**Southern Nuclear Operating Company  
Vogtle Electric Generating Plant Units 3 and 4  
Request for License Amendment and Exemption:  
Reactor Coolant System (RCS) Flow Coastdown (LAR-18-025)**

Enclosure 3 identifies the requested changes and provides markups depicting the requested changes to the VEGP Units 3 and 4 licensing basis documents.

**Proposed Changes to Licensing Basis Documents**

**(LAR-18-025)**

**Revise COL Appendix C Figure 2.1.2-2, Flow Transient for Four Cold Legs in Operation, Four Pumps Coasting Down, and corresponding plant-specific Tier 1 Figure 2.1.2-2, as shown below.**

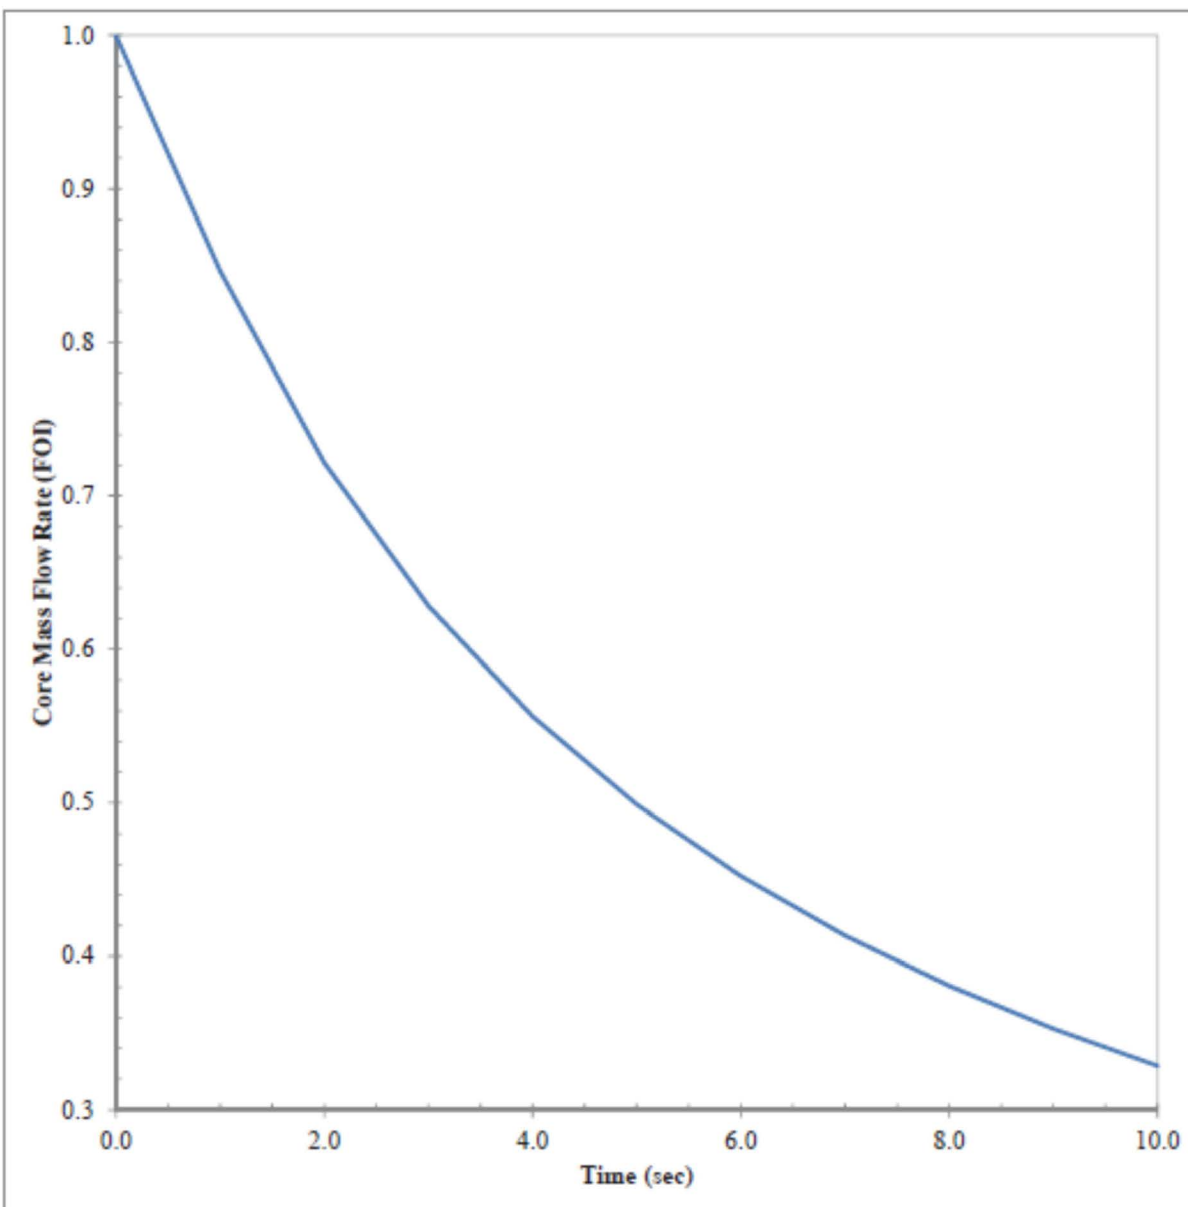
For hot functional test considerations, the RCP coastdown curve in UFSAR Chapter 15 is used as a basis, but adjusted from 100% power with a full power  $\Delta T$  to HZP to reflect a revised ITAAC-related test acceptance criterion provided in Figure 2.1.2-2.

Note that the proposed change to the ITAAC-related Figure 2.1.2-2 also changes the y-axis from “Core Coolant Mass Flow (Fraction of Nominal)” to “Core Mass Flow Rate (FOI).” A note is added to the revised figure to indicate “FOI” stands for “Fraction of Initial.” This change is made to clarify that the plot is a fraction of the initial flow in the analysis, and there is no technical consequence to the supporting analysis or to the RCP coastdown as a result of this axis labeling change.

- UFSAR Figure 15.3.2-1 – Replace figure for revised analysis results
- COL Appendix C Figure 2.1.2-2 (and the corresponding plant-specific Tier 1 figure) – Replace figure for revised analysis results (modified to reflect test conditions) and add note to bottom of figure to address use of “FOI”

Note: FOI = Fraction of Initial

**Revise UFSAR Figure 15.3.2-1, Core Mass Flow Transient for Four Cold Legs in Operation, Four Pumps Coasting Down, as shown below.**

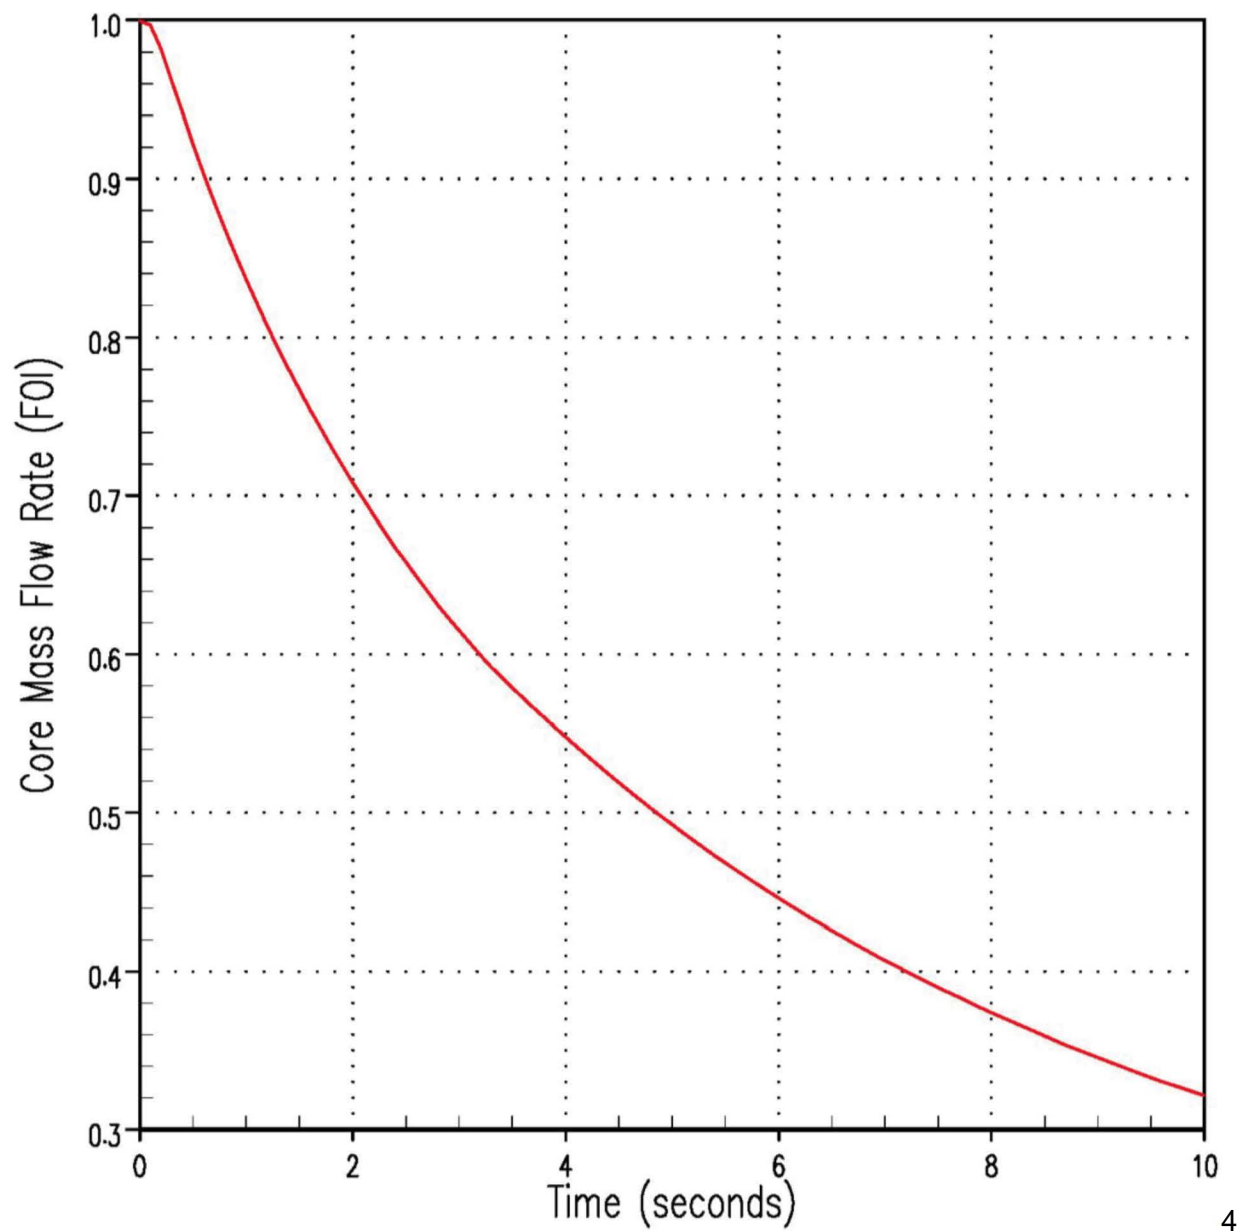
Both proposed figures (UFSAR Figure 15.3.2-1 and the ITAAC-related Figure 2.1.2-2) account for RCP design changes that are incorporated into a revised CLOF analysis:

- i) for revised vendor-supplied RCP homologous curves,
- ii) for revised RCP fluid friction losses, and
- iii) for revised RCP flywheel ring material.

The revised RCP characteristics were modeled in the safety analyses and are reflected in the revised coastdown curve proposed for UFSAR Figure 15.3.2-1. The revised safety analyses remain conservative since the acceptance criteria continue to be met.
